Product Change Notice - Announcement

PCN no.: P25-2015-001
Date: 2015-04-27
PCN Type: Information
Subject: EGO[®] Radiant Heating Elements - omission of P1 tab
Reference: Product Management - Tilo Fucik

4. Identification of change

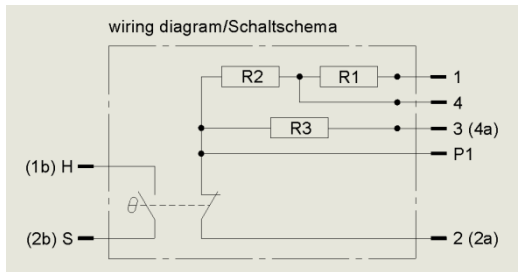
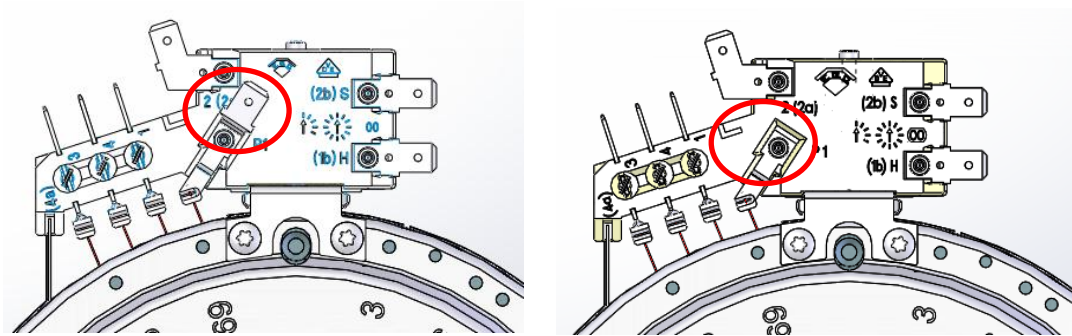
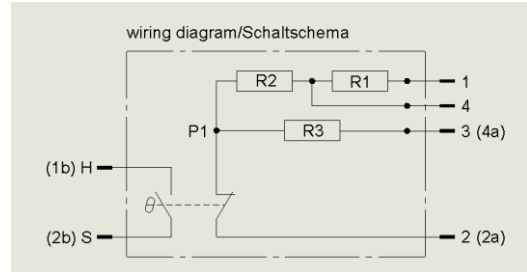
Continuous improvement of E.G.O.'s products and market observation has given the proof that the P1 tab on the below-mentioned EGO[®] types is not needed. Actually, the P1 terminal could even lead to failures or miswiring during the assembly of the heater in the hob.

The function of the limiter remains unchanged.

This change is made in order to help to increase the product quality within the hob production.
